UNITED STATES PATENT AND TRADEMARK OFFICE

APPLICATION NO.	FILING DATE	FIRST NAMED INVENTOR	ATTORNEY DOCKET NO.	CONFIRMATION NO.
10/663,702	09/17/2003	Atsuki Kasashima	Q77534	3972
7590	05/06/2004		EXAMINER	
SUGHRUE, MION, ZINN, MACPEAK & SEAS, PLLC 2100 Pennsylvania Avenue, N.W. Washington, DC 20037-3213			GORDON, RAEANN	
			ART UNIT	PAPER NUMBER
			3711

Office Action Summary	Application No.	Applicant(s)	
	10/663,702	KASASHIMA, ATSUKI	
	Examiner	Art Unit	
	Raeann Gorden	3711

DETAILED ACTION

FIG. 1

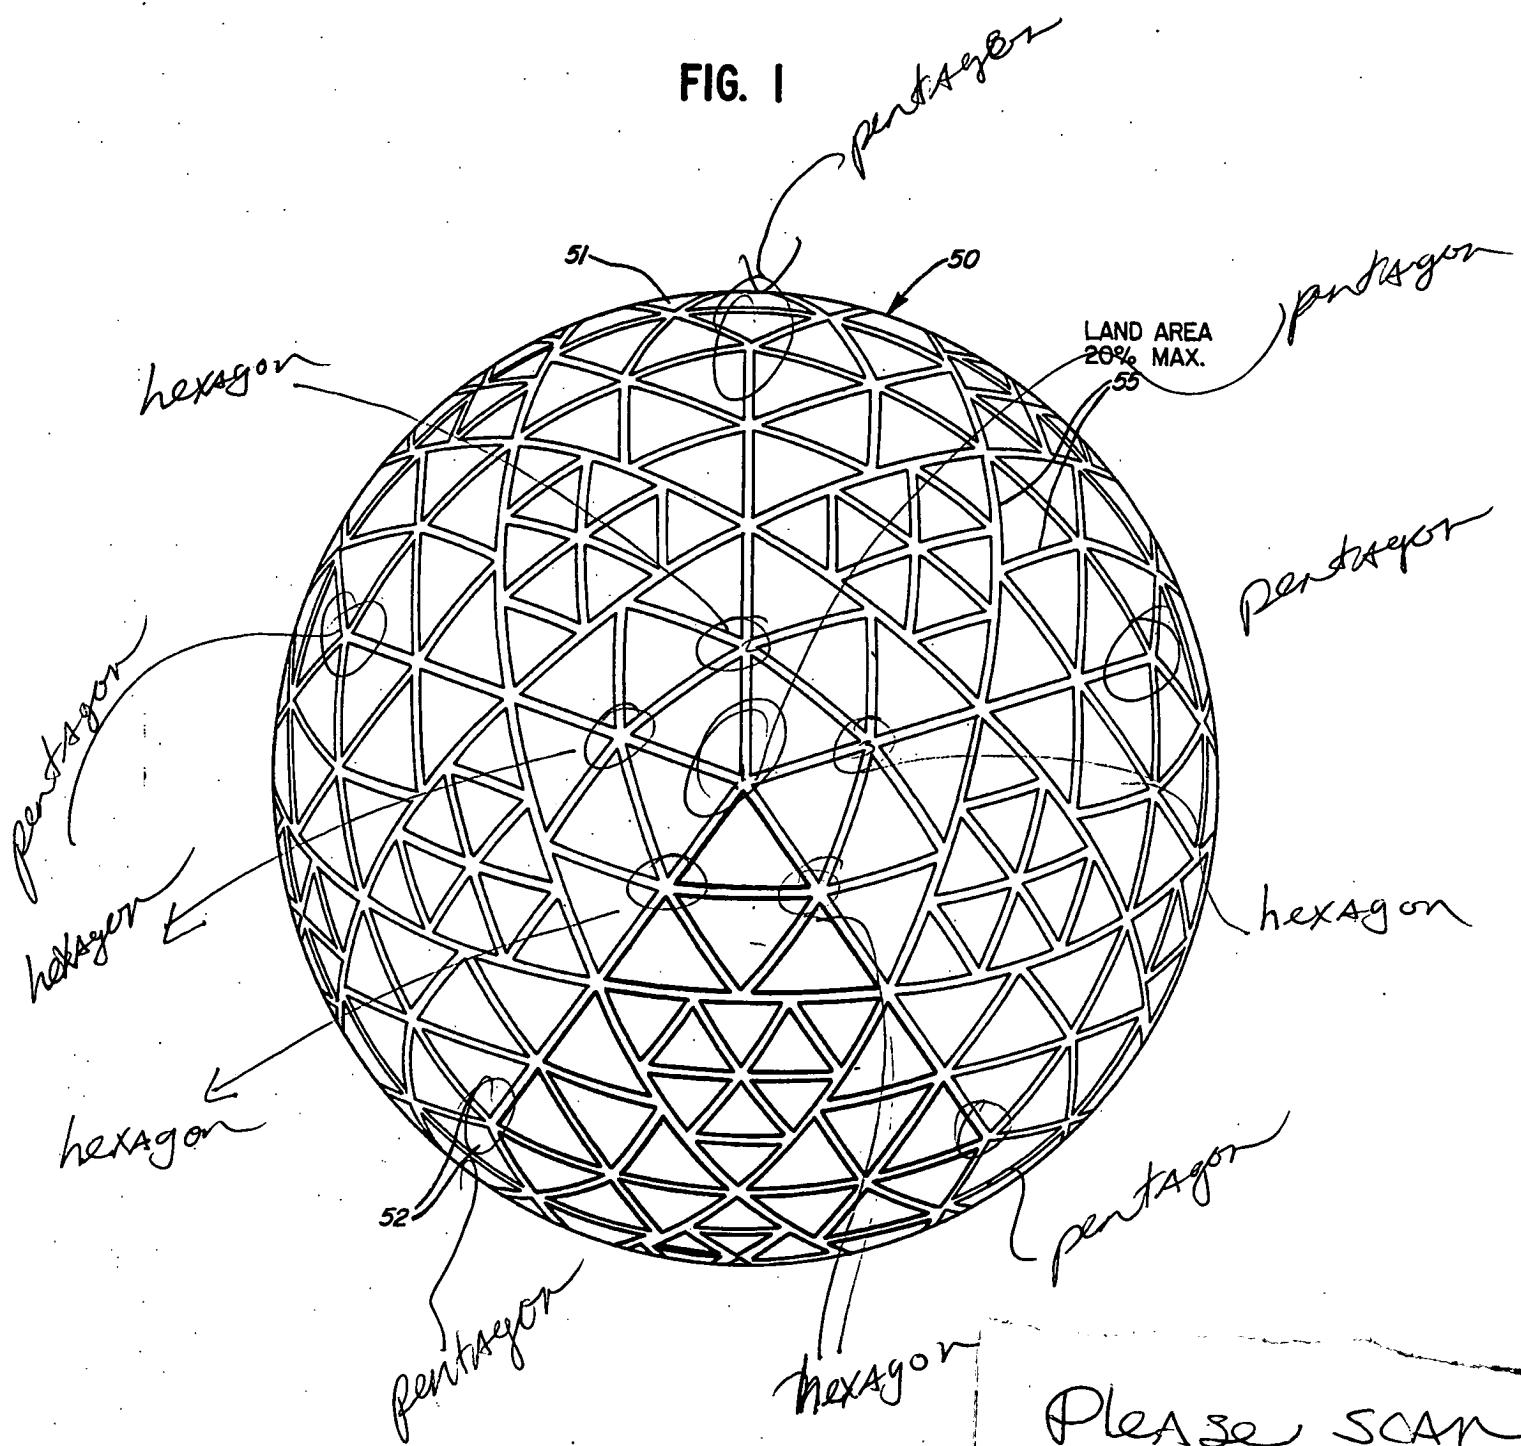
Claims 1-4 and 9-12 are rejected under 35 U.S.C. 102(b) as being anticipated by Aoyama (4,830,378). Regarding claim 1, Aoyama discloses a golf ball comprising triangular dimples formed by ridge-like lands (fig 1). The sides of the triangle dimples are between 2 and 9 mm. See figure 3 wherein the radius is given, the sides are inherently longer than the radius since the radius is the distance from the center of the triangle to each apex. The radius values given are 0.1238, 0.1291, 0.0846 and 0.0882 inch, which convert to 3.14, 3.28, 2.14, and 2.24 mm, respectively. Since the radius is at the lower end of applicant's range the sides will inherently be larger than the radius but smaller than 9mm. Regarding claim 2, the triangular dimples are arranged across the entire surface of the golf ball (fig 1). Regarding claim 3, figure 1 displays twelve pentagons each defined by combining five triangular dimples (see attached figure 1 for location). Figure 1 also displays hexagons formed by combining six triangular dimples (see attached figure 1 for location). Regarding claim 4, figure 1 shows one hemisphere with six pentagons, the opposite side inherently has six pentagons as well. Regarding claim 9, the dimples have a convex bottom (col. 4, lines 40-41). Regarding claims 10
